THAT'S IT KNIT (EXTENSION)

27 February 2024

1. Building Information

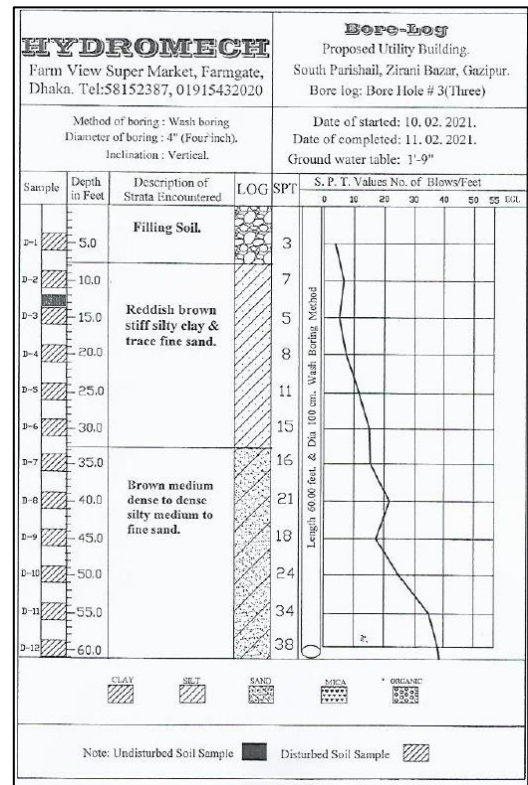
Observation-2: Soil investigation report does not comply with BNBC requirements. (7-Storeyed Utility Building).

Description: During inspection, a geotechnical investigation report has been provided by the factory for the existing 7 storied factory building. The report consists of 6 borehole data up to a depth of 18m. As per BNBC table no 6.2.13 requirement a 30m bore is required to determine the average SPT “N” value. In the design report Site class “SD” has been considered to determine the Seismic design category based on this soil test report. The building engineer is required to investigate the soil layer at a minimum depth of 30m and revise the design report accordingly.
